DEVIATION REQUEST AND DECISION FORM

Project Name : CLOVERLEAF SUBDIVISION
Schedule No.(s) : 7124202236, 7124202237, 7123102041, 7123102044
Legal Description : SEE ATTACHED – Exhibit C

WHITE CLOVER DRIVE AND LEGGINS WAY INTERSECTION SIGHT DISTANCE

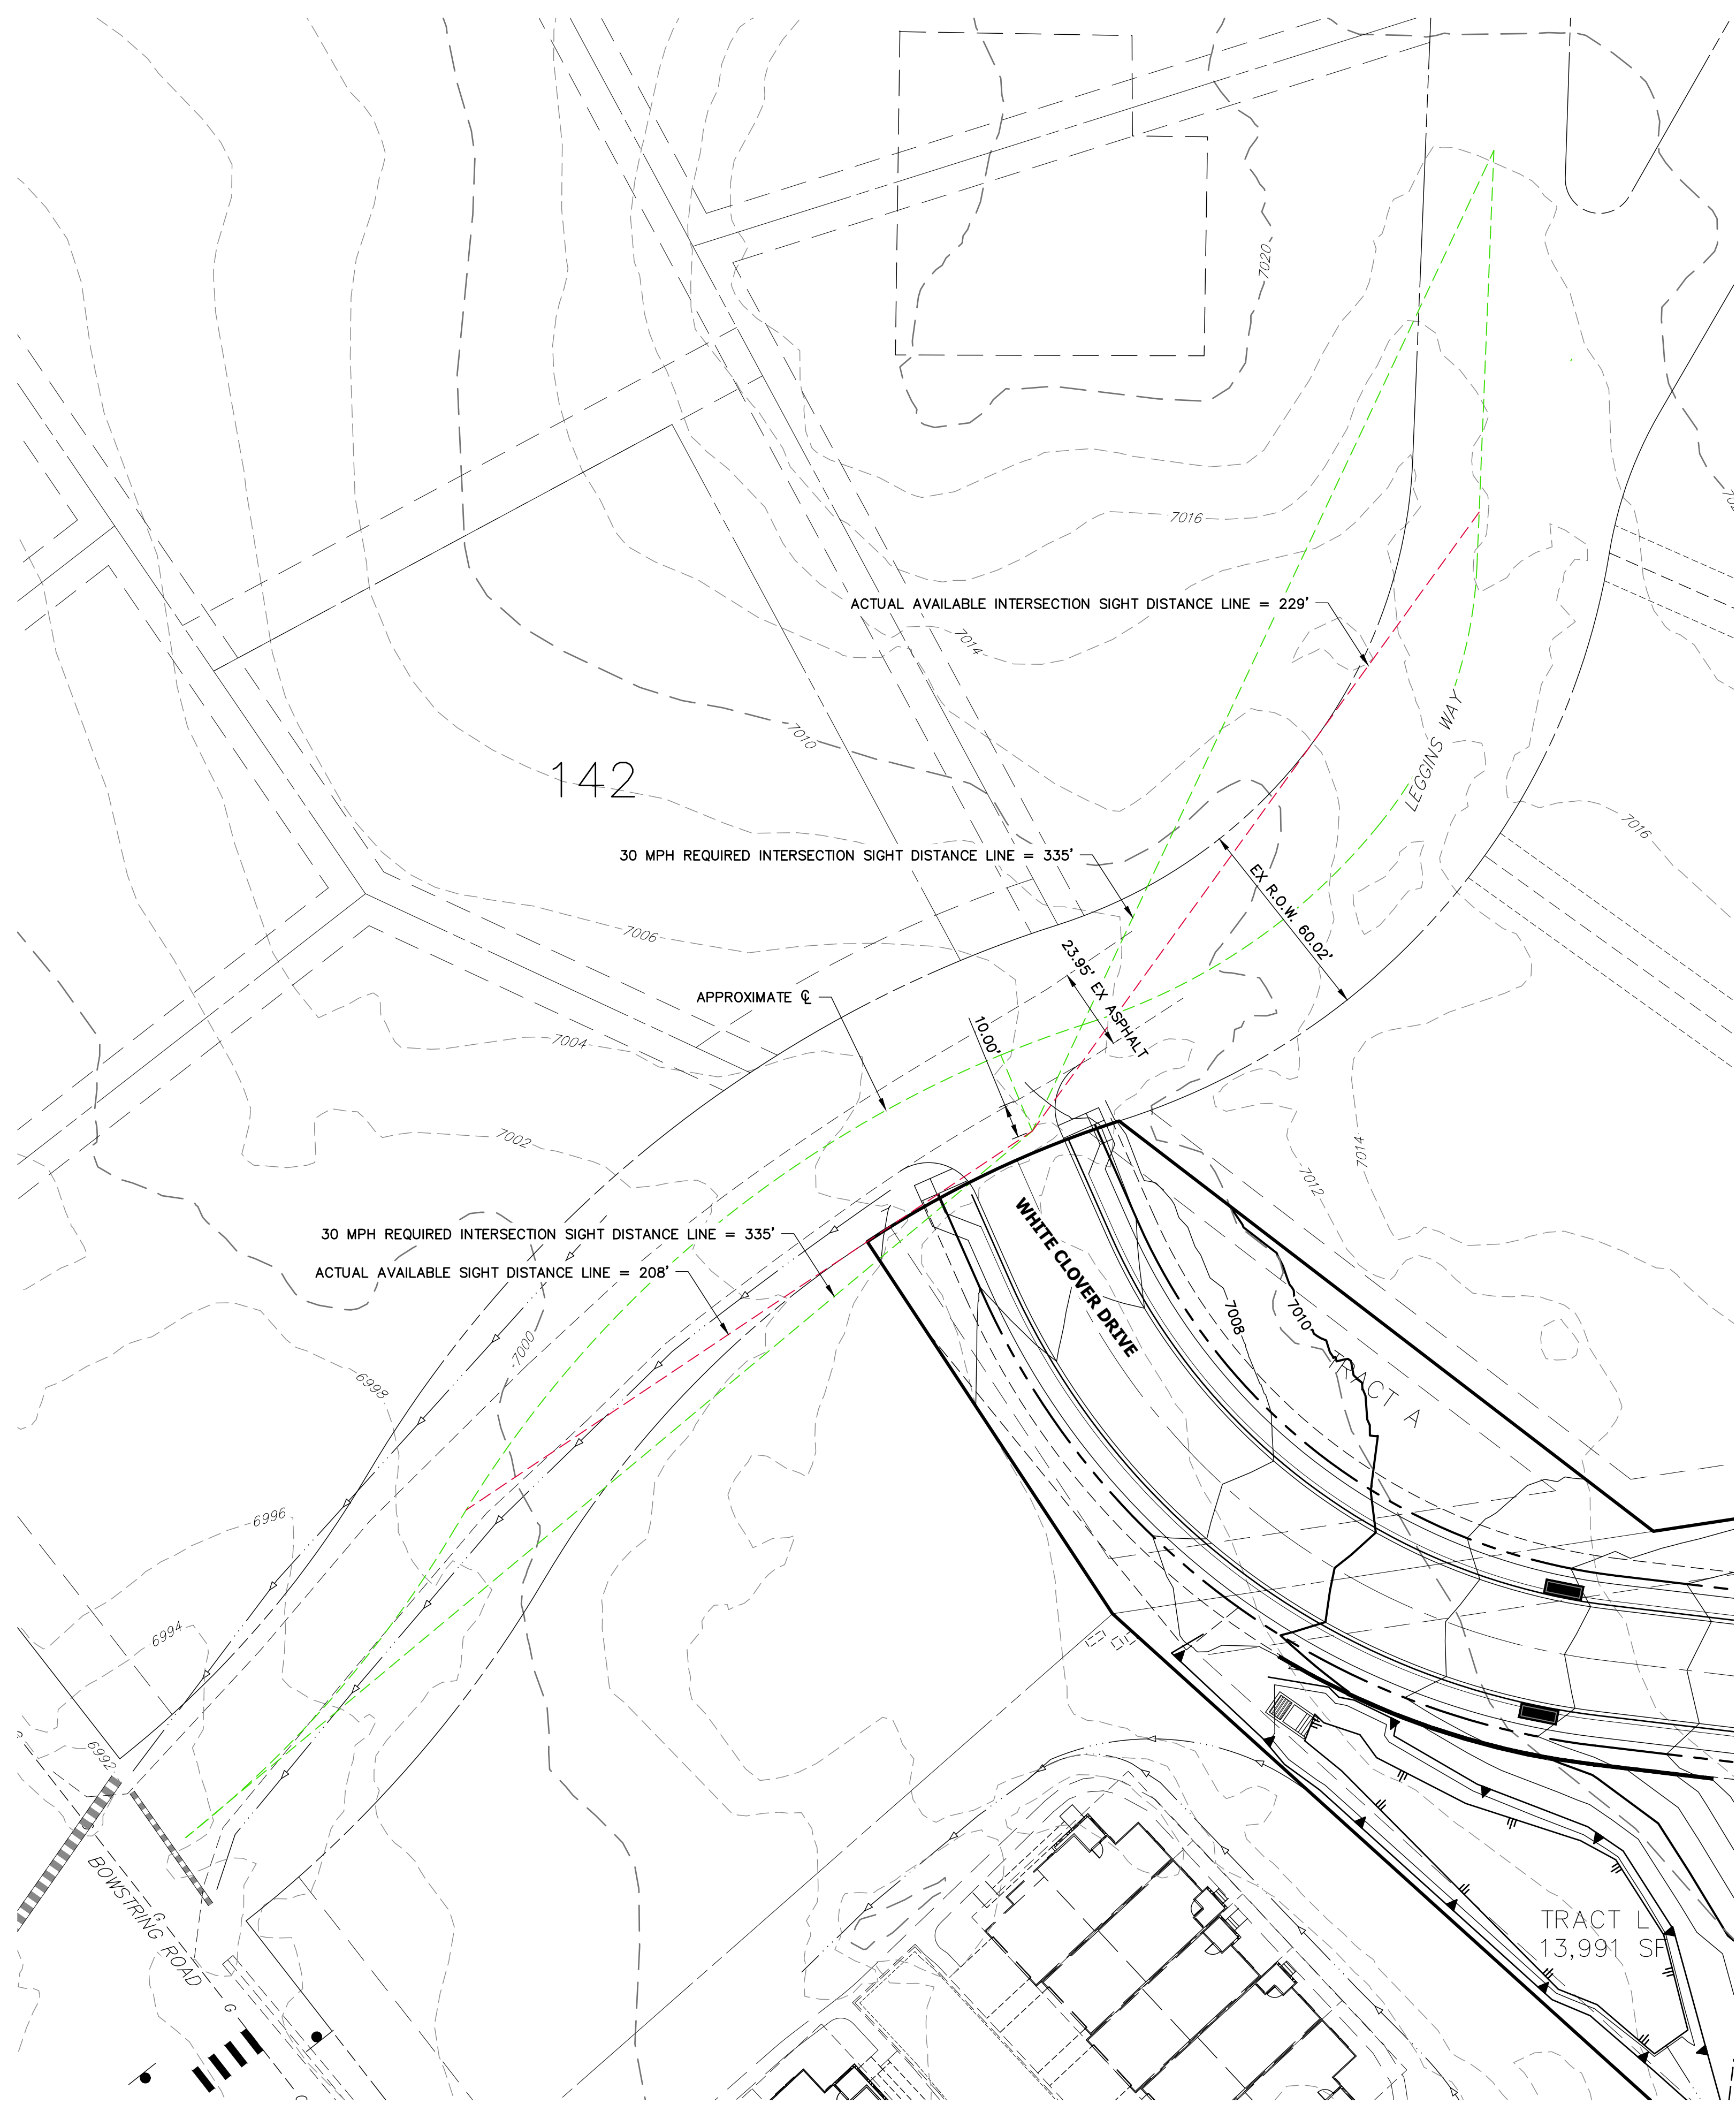
ECM criteria for intersection sight distance at local road intersection of White Clover Drive (urban local cross section) and Leggins Way (rural local cross section). Section 2.3.7.C.5 Intersection Sight Distance. Table 2-22 for 30 MPH design speed, intersection sight distance is 335 feet.

The reason for the requested deviation is due to the existing horizontal layout of Leggins Way Road and the physical limitation of the proposed intersection placement. Cloverleaf Subdivision was laid out to have a public road access to Leggins Way and the intersection was placed to intersect at 90 degrees. The intersection was placed as far north as possible on the applicant's property to provide as much sight distance as possible to the north, since the traffic from the south is most likely at a lesser speed after turning off Bowstring.

To provide adequate ECM criteria, easements would have to be obtained from the property to the north and south. Both properties have existing structures with currently no obstructions. The sight distance within the ROW from the north is 229 feet. The sight distance within the ROW from the south is 208 feet. See Attached Exhibit A for a graphical representation of the proposed intersection sight distances. See Exhibit B for a google earth exhibit showing the existing structures on the adjacent properties.

Applicant proposes to place signage both north and south to warn drivers of the upcoming intersection, to mitigate the existing condition.
